City of Biddeford
Planning Board
July 01, 2020 6:00 PM Via ZOOM

Planning Board MINUTES (DRAFT)

PLANNING BOARD REPORT

PLANNING BOARD REPORT

FOR PERMITTING ONLY
NOT FOR CONSTRUCTION

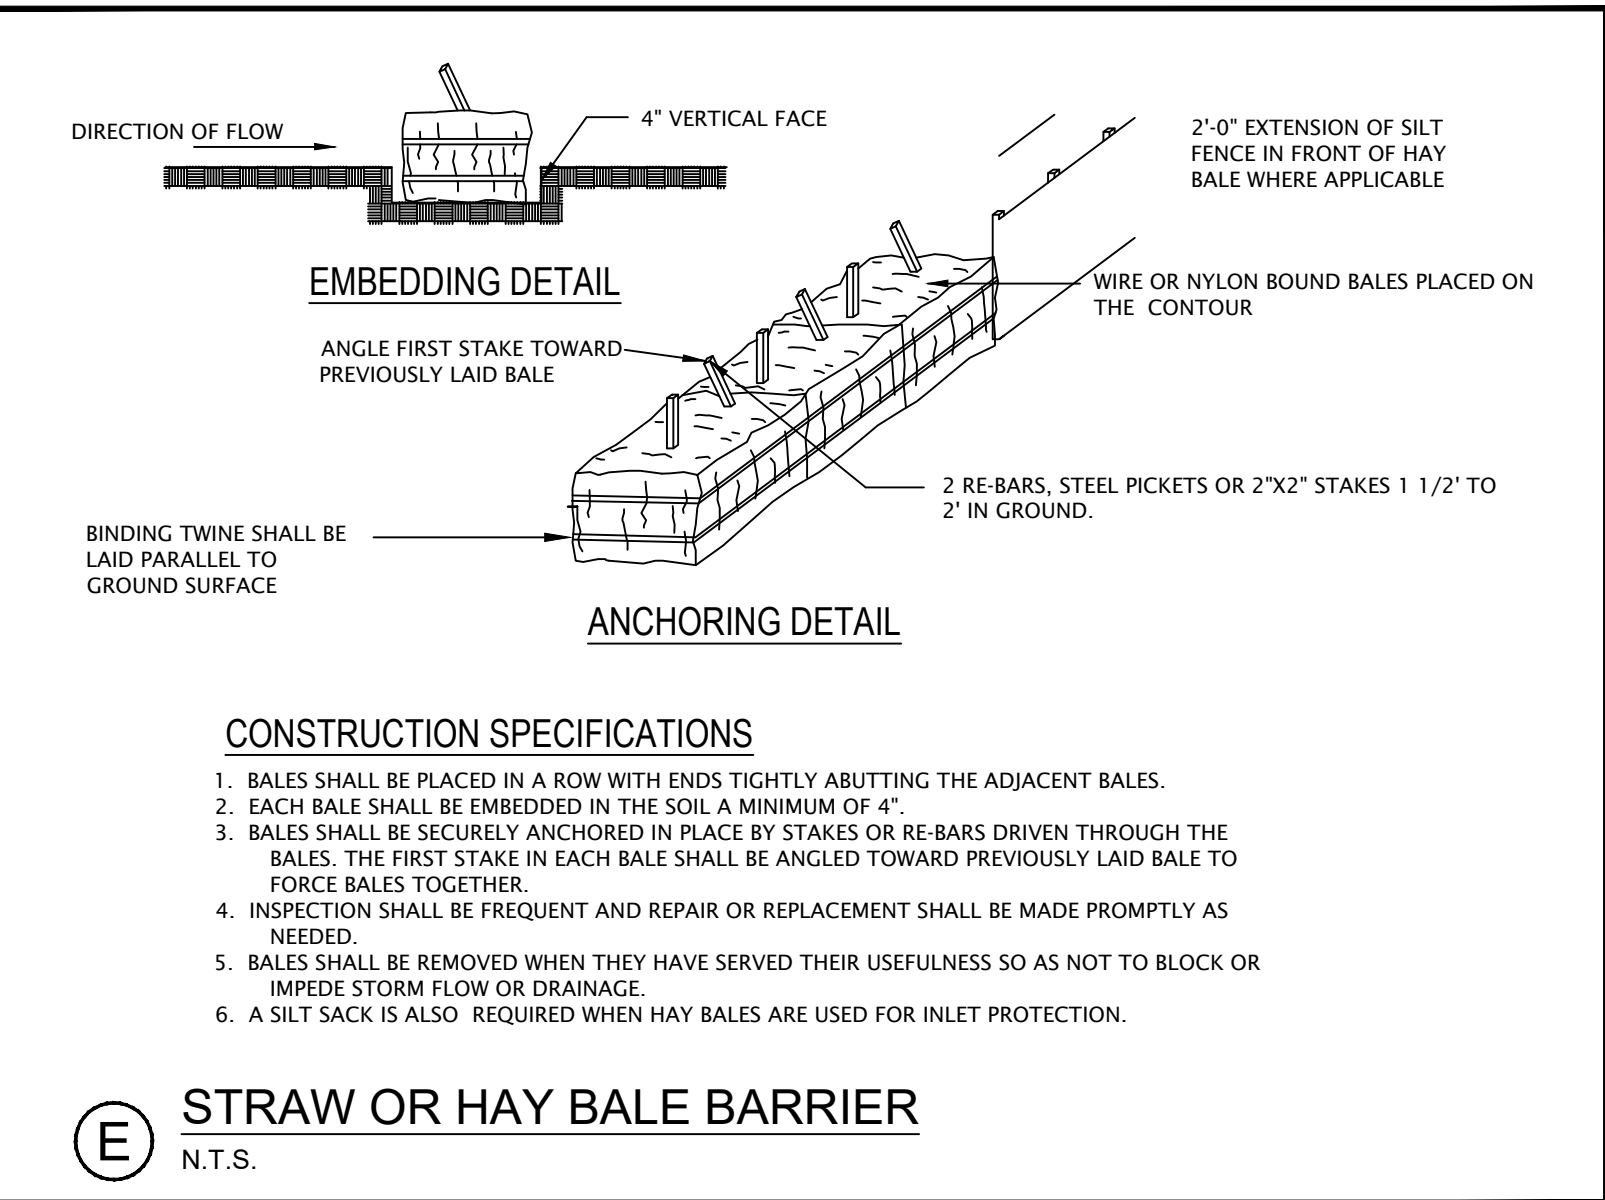
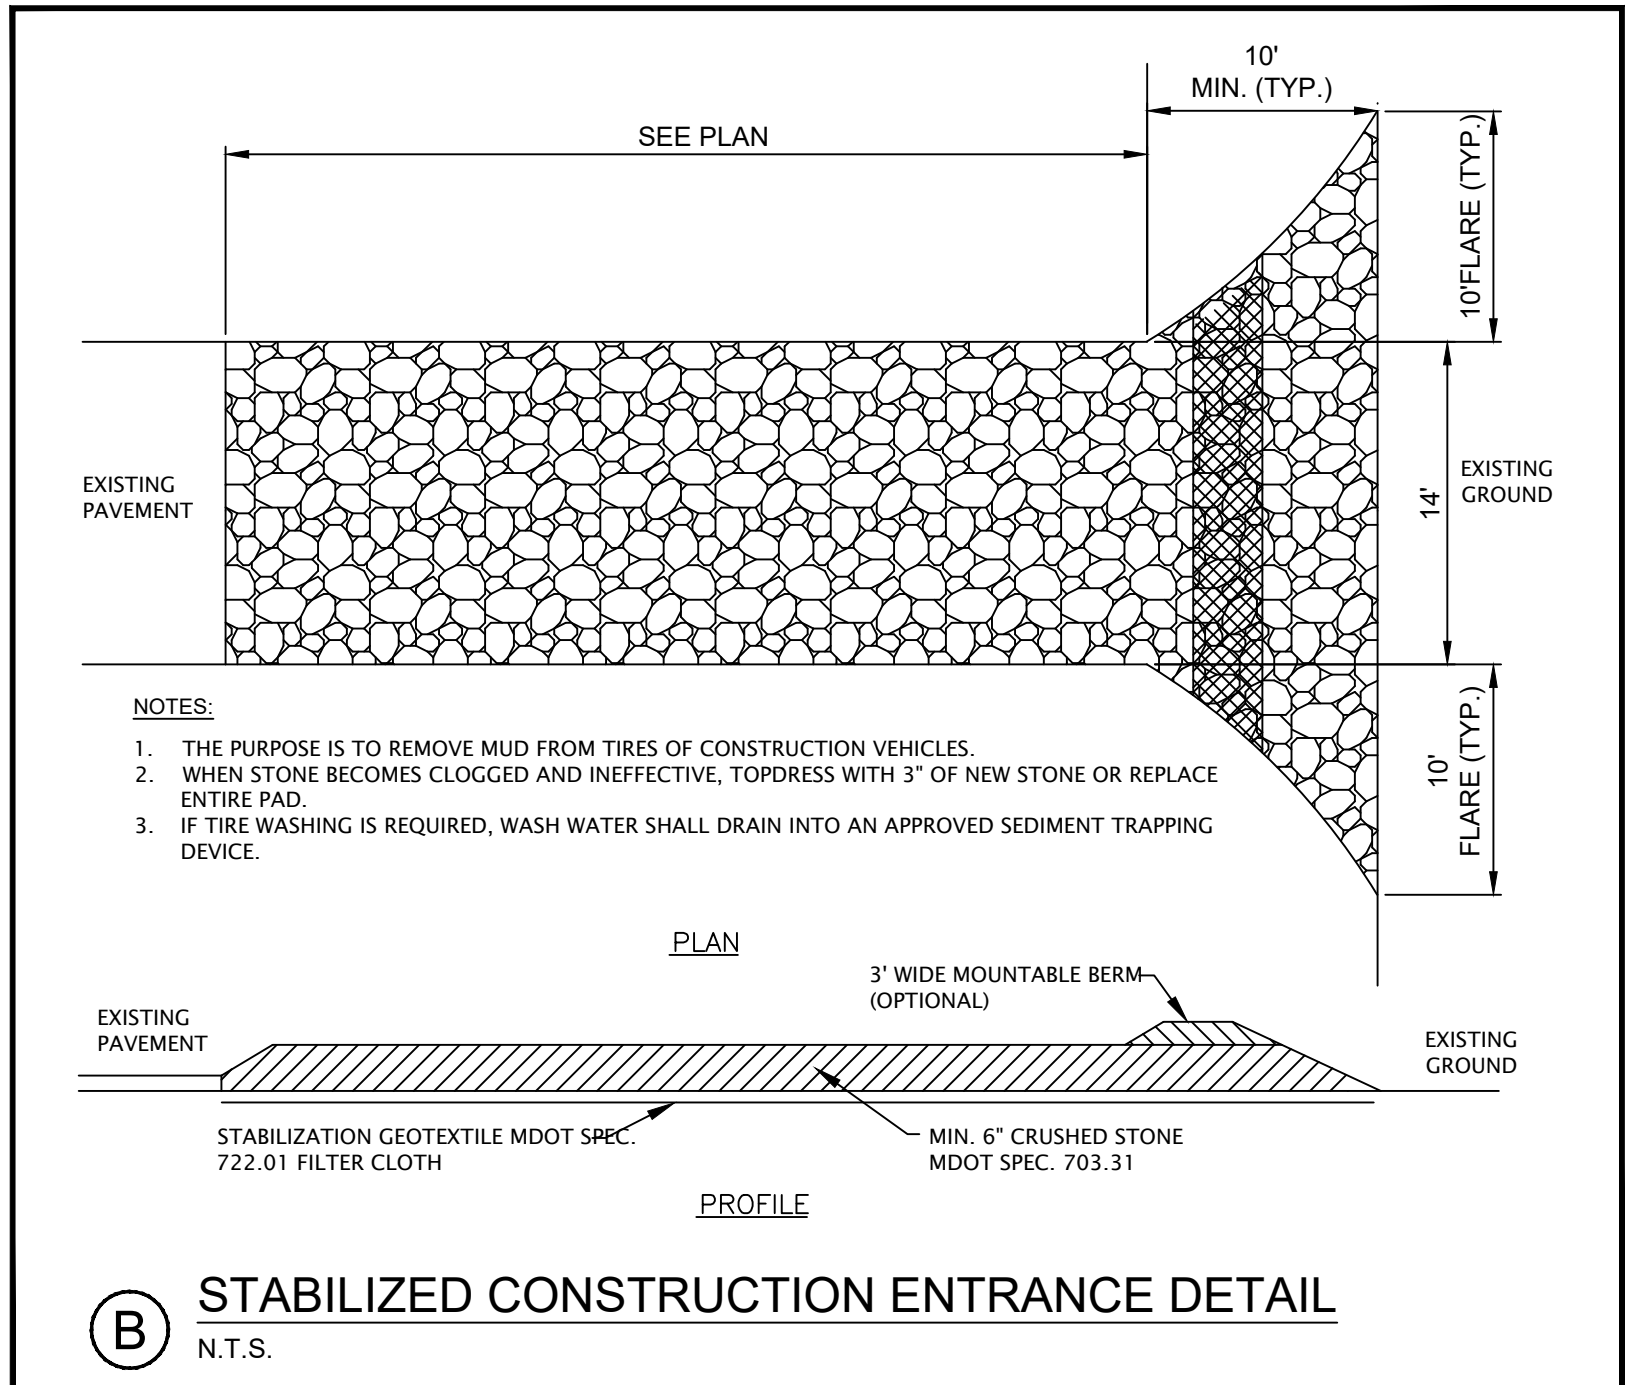
- Addressed.
 - Addressed.
 - Addressed.
 - The riprap apron table shown on drawing C-301 should include dimensions associated with a 24 inch diameter pipe.
